DATE: June 7, 2019

SUBJECT: ADDENDUM #3 TO THE BIDDING DOCUMENTS FOR:  
**BID GROUP #6**  
**MASTER FACILITY PLAN IMPLEMENTATION**  
**COMMUNITY HIGH SCHOOL DISTRICT 99**  
**1436 NORFOLK STREET**  
**DOWNERS GROVE, IL 60516**

**BG6 BP2 Revised Concrete Scope**  
**BG6 BP3 Revised Precast Floor Plank Scope**

**S2.2B-C1**

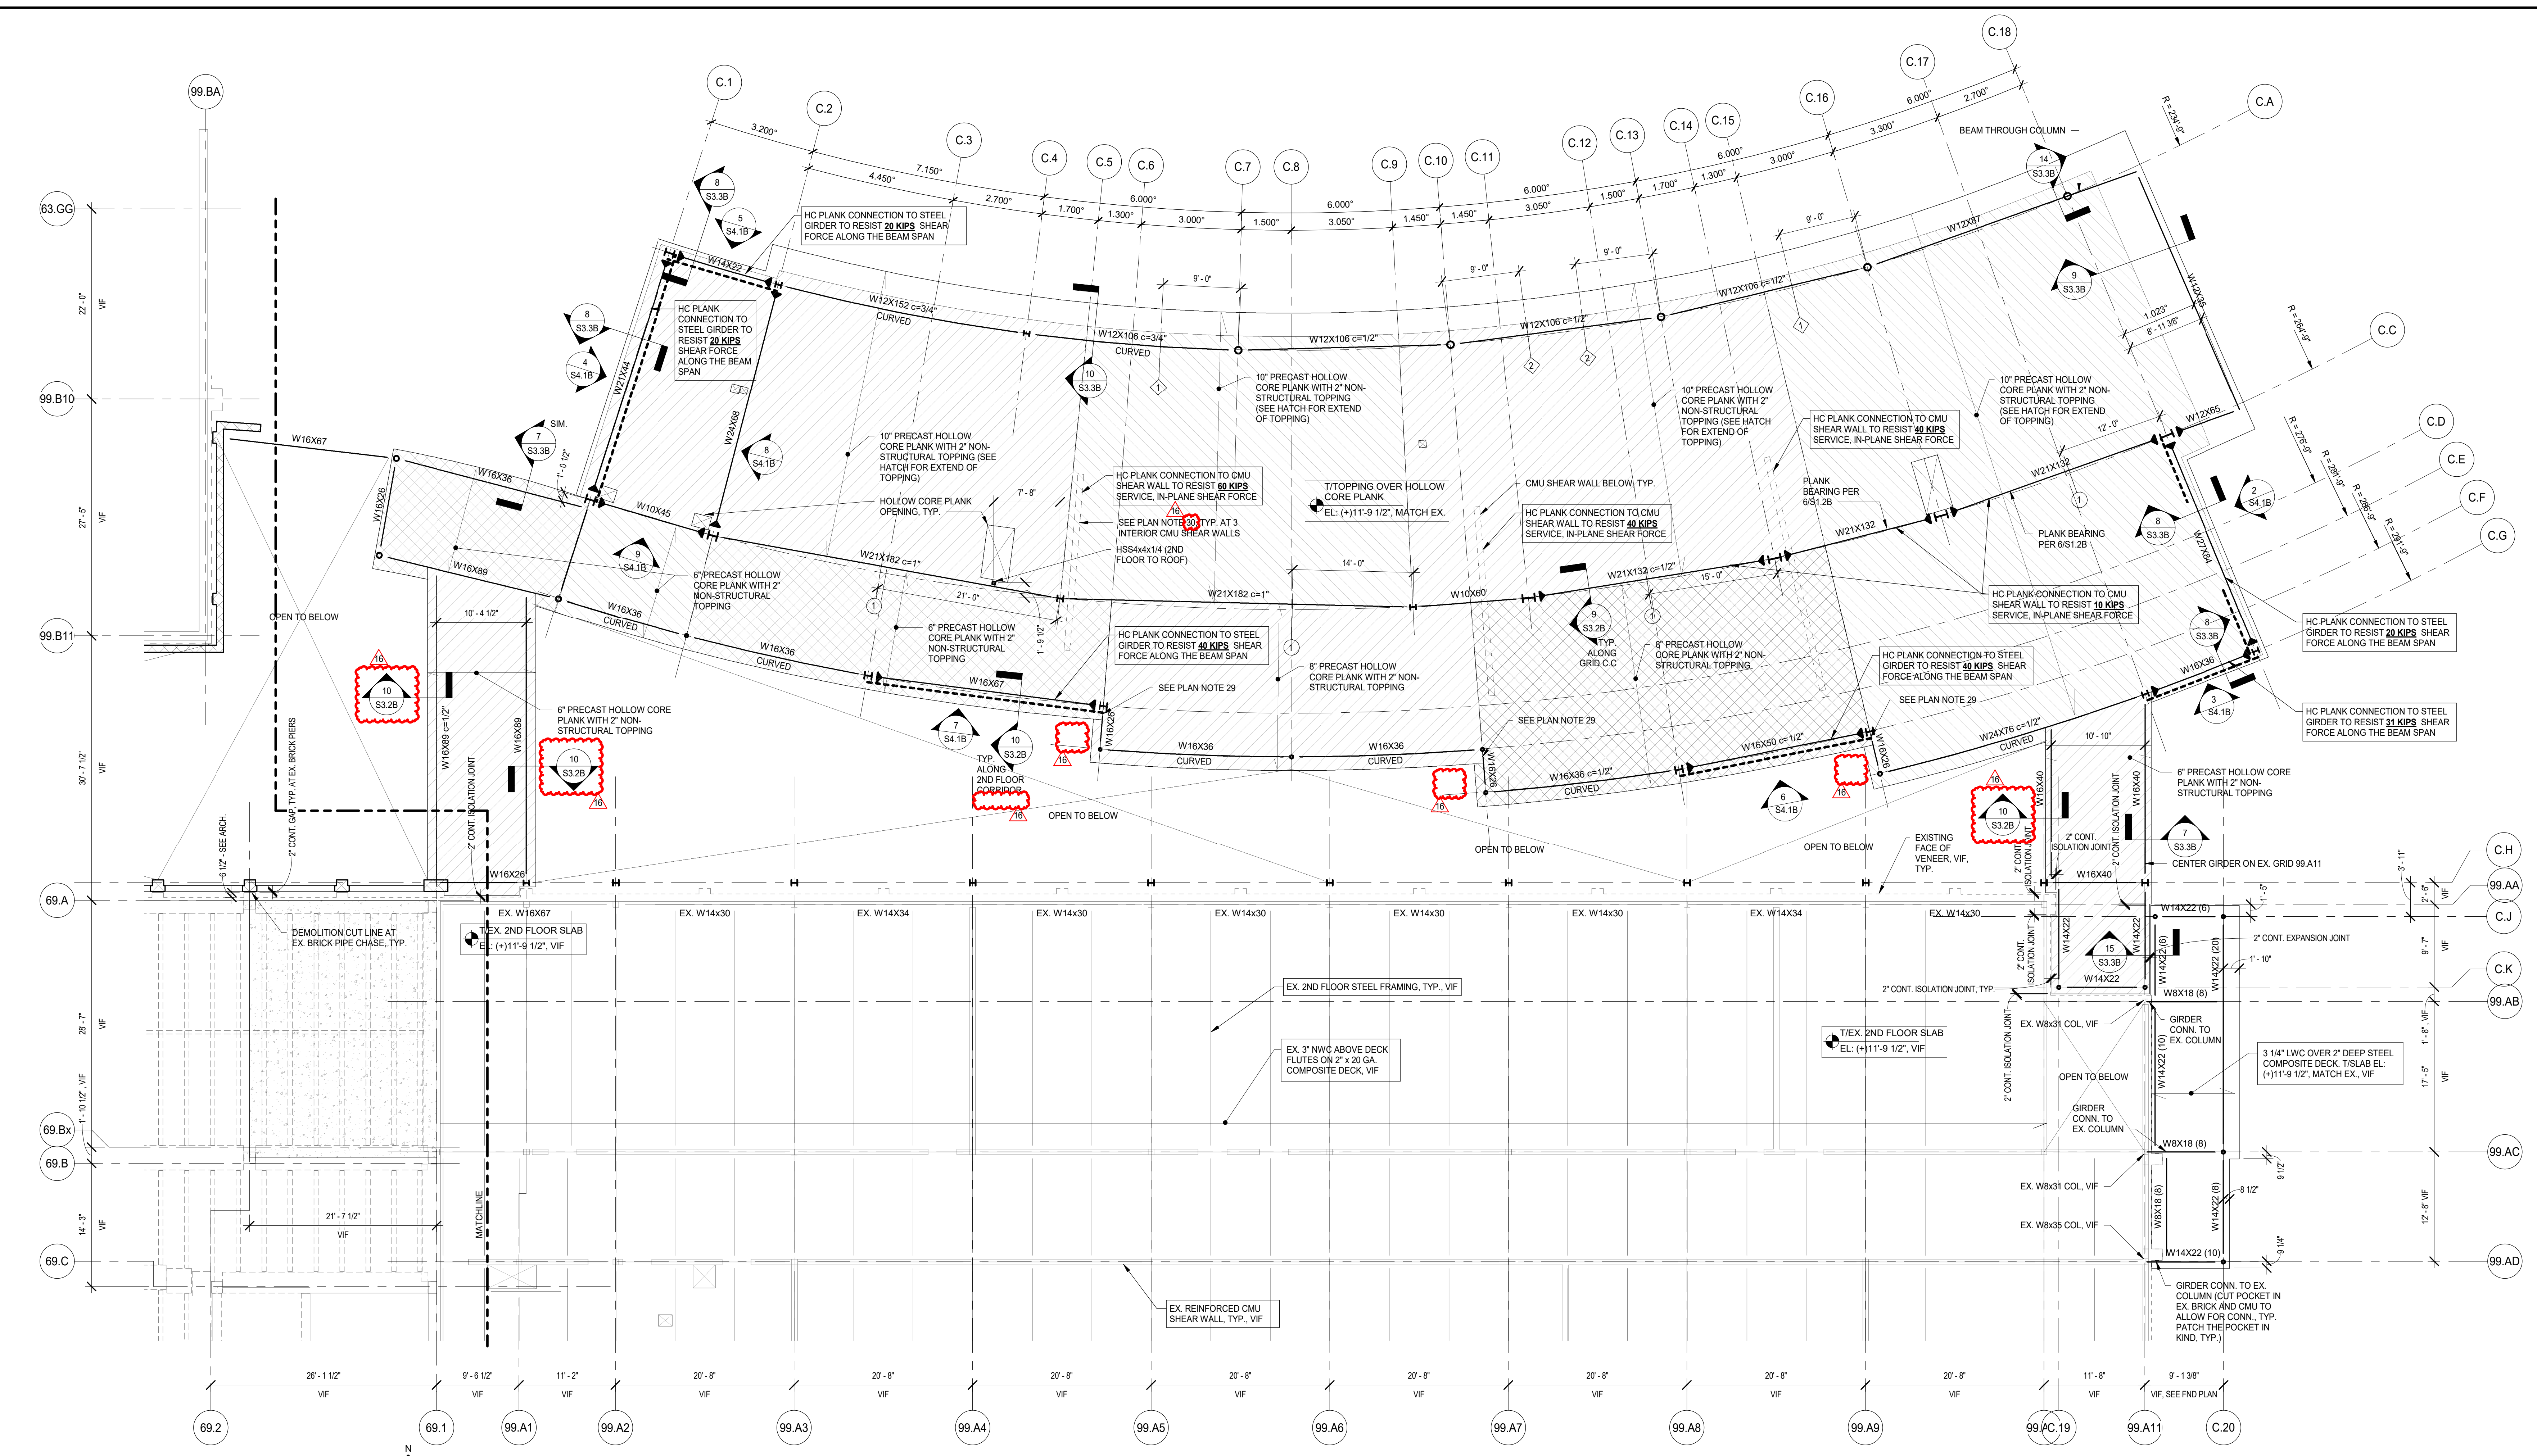
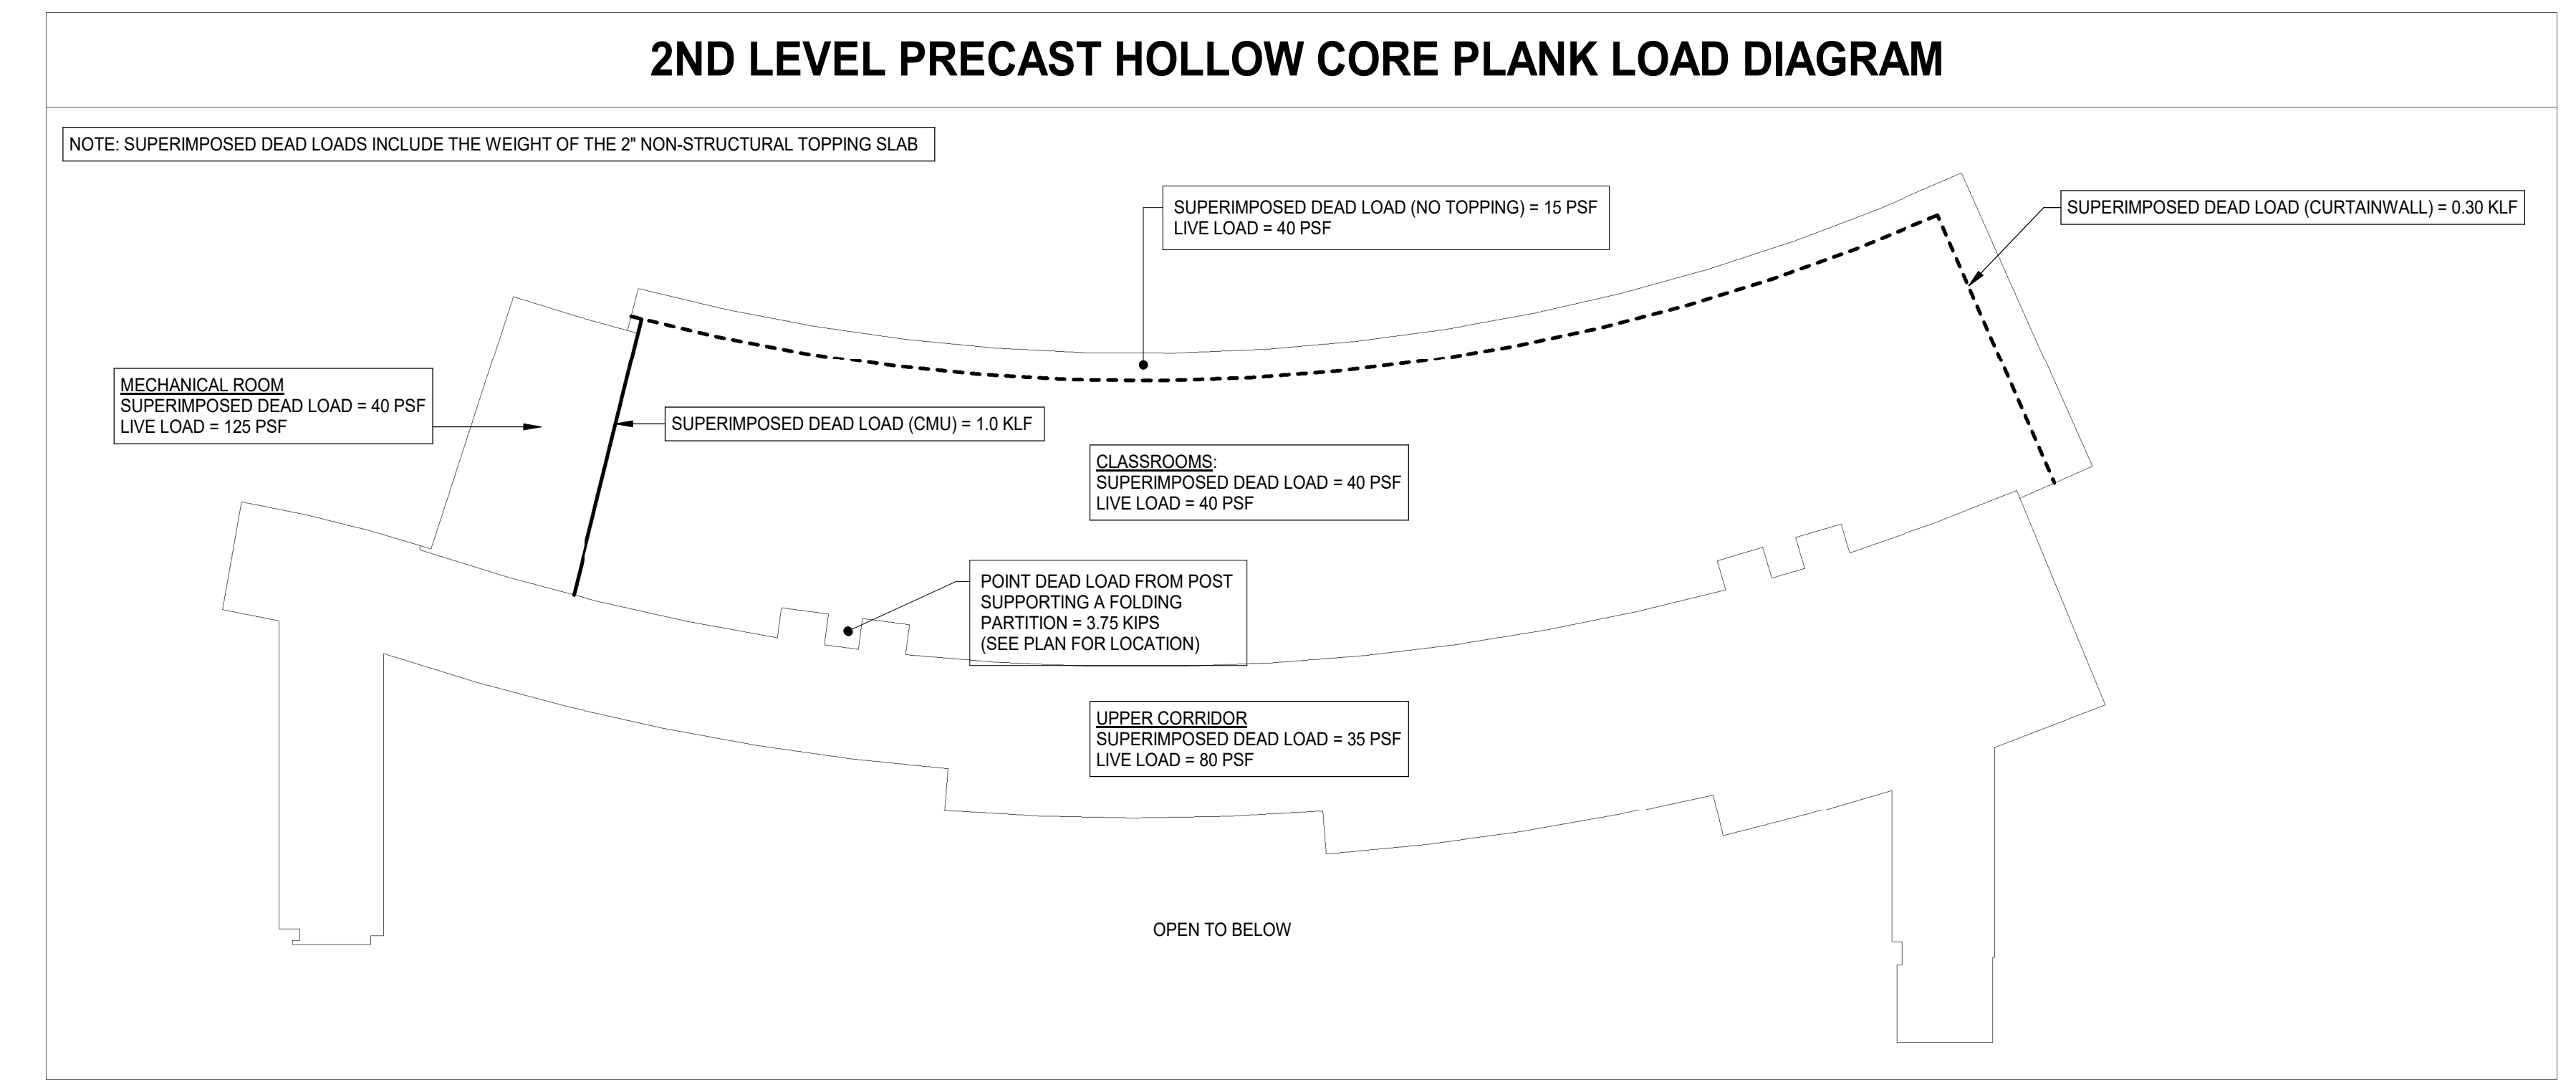
1. Sheet S2.2B-C1 2ND FLOOR FRAMING PLAN – AREA C.1 (**Full size sheet reissued**):
  - a. Slab edge detail along C.D, C.E, C.F AND C.G modified.
2. Sheet S3.2B NON-TYPICAL SECTIONS AND DETAILS (**Full size sheet reissued**):
  - a. Continuous embed plate added to detail 10.
